A New Agricultural Facility For Dounty Tennesse

issued	01-29-2016		
checked	SDW		
approved	SDW		
drawn	DRH		
project no. 201538-SW15149			
drawing nai	me		
FOUND	DATION AND

ADDENDUM NO. 1 02-16-2016

project no. 201538-SW15149 drawing name SECTIONS, DETAILS AND GENERAL NOTES

S-10

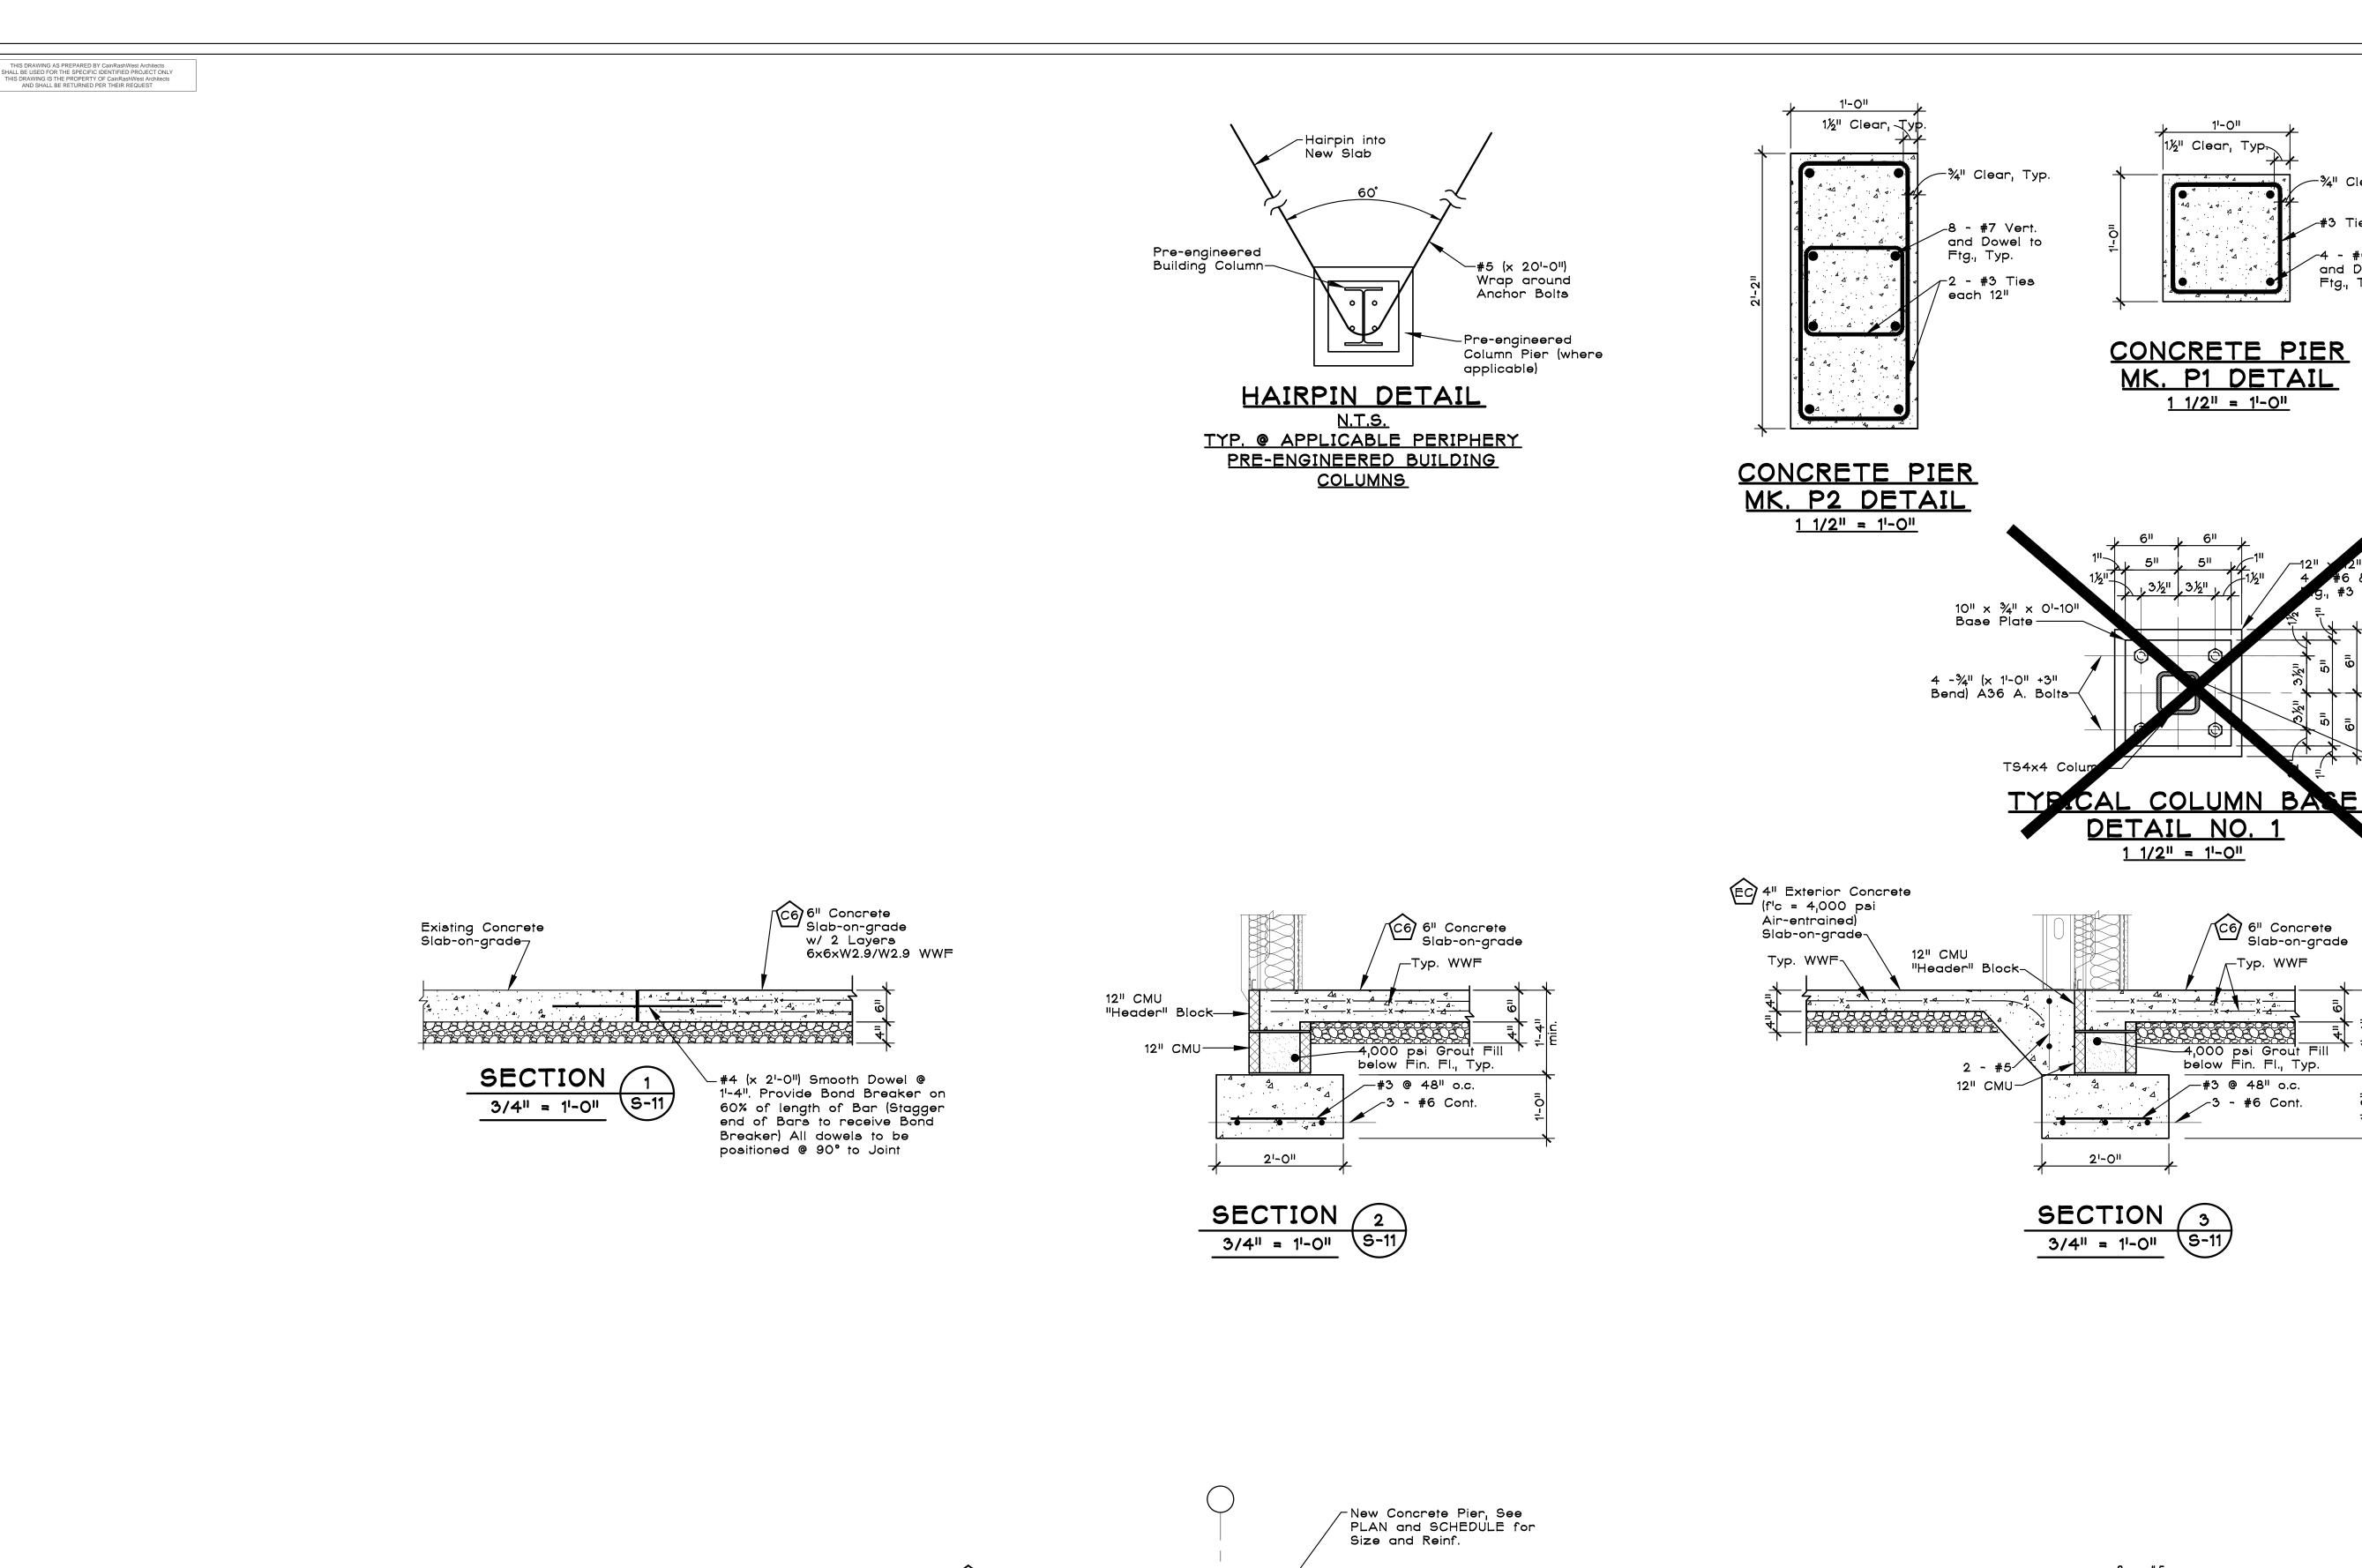
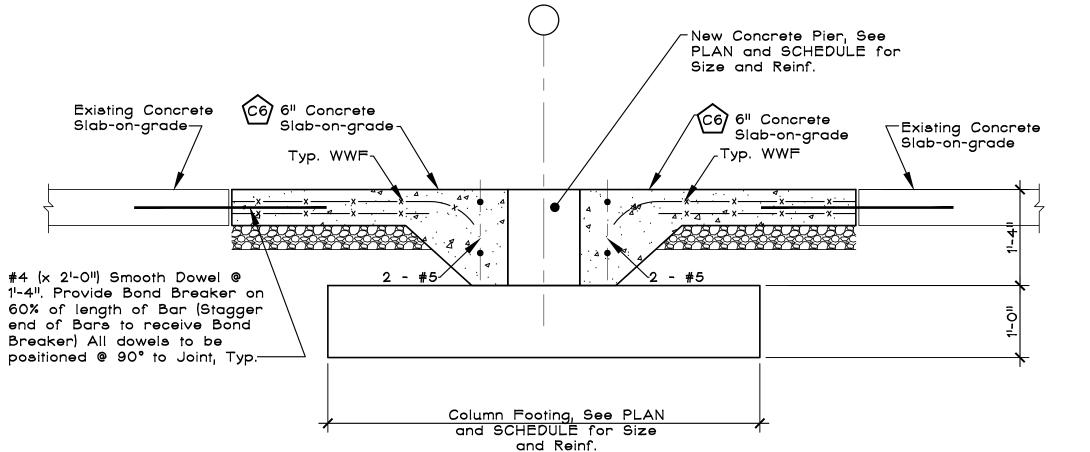
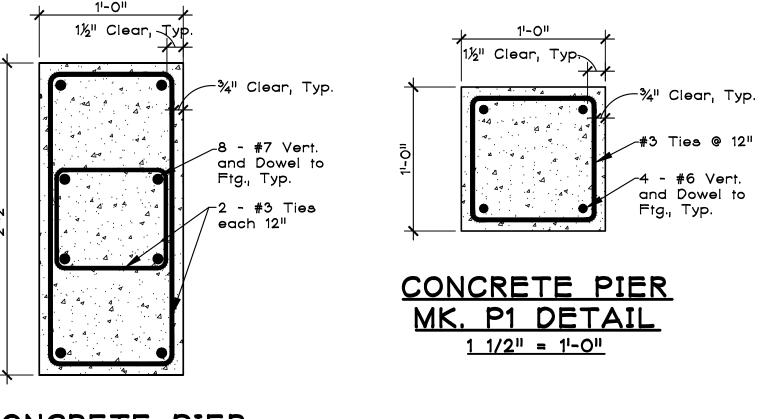
6x6 Pressure Treated Wood Posts w/
"Stand-off" Post Bases equal to SIMPSON
Strong Tie Model No. LCB66, 12 Ga on
Concrete Pier Mk. P1.

CONCRETE PIER SCHEDULE					
Conc. f'c = 3,000 psi Reinf.: ASTM A615, Grade 60					
MARK	PIER SIZE	PIER REINFORCING			
P1	12" × 12"	4 - #6 Vert. and dowel to Footing #3 Ties @ 12"			
P2	12" × 26"	8 - #7 Vert. and dowel to Footing 2 - #3 Ties each 12			
See CONCRETE PIER DETA		on sheet S-11

#3 Ties @ 12" DELETE TYP. **COLUMN BASE** DETAIL
